### TENNESSEE VALLEY AUTHORITY (TVA) SEQUOYAH NUCLEAR PLANT (SQN) UNIT 1

#### RESPONSE TO REQUEST FOR ADDITIONAL INFORMATION REGARDING THE CYCLE 13 STEAM GENERATOR TUBE INSERVICE INSPECTIONS

**Sequoyah Unit 1 Tubesheet**

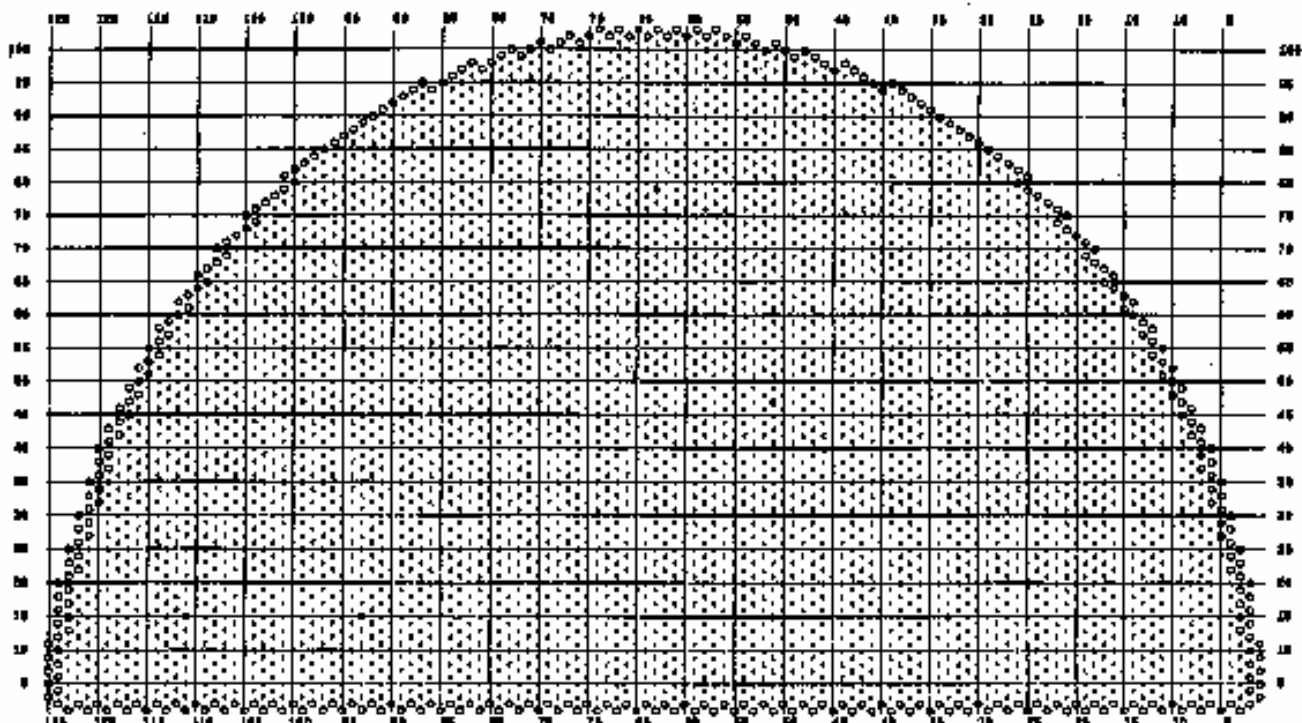
Your report provided information about flaws in specific tubes and at specific locations within a tube. In order for the U.S. Nuclear Regulatory Commission staff to better understand where your indications are being detected and for future reference, please provide the following information regarding the design of your replacement SGs: a tubesheet map, a tube support plate diagram, the heat transfer surface area, the tubesheet thickness (with and without the clad), the lattice grid thickness, the tube support plate thickness, and a description of the U-bend support system, including the thickness and the tubing supported by the various supports. In addition, discuss whether you have a flow distribution baffle to distribute flow at the top of the tubesheet, including the thickness.

The tube sheet, as shown above, is a triangular pitch design with tubes designated by row and column. There are 103 rows and 125 columns in each leg of the four steam generators. The tubes are expanded full length of the tube sheet using a hydraulic expansion process. There are 13 blank spaces in each tubesheet for stay rods. The locations of these blanks are as follows:

Stay rod tube numbers					
	79-39	79-63	79-87		
	47-27	47-51	47-75	47-99	
15-15	15-33	15-51	15-75	15-93	15-111
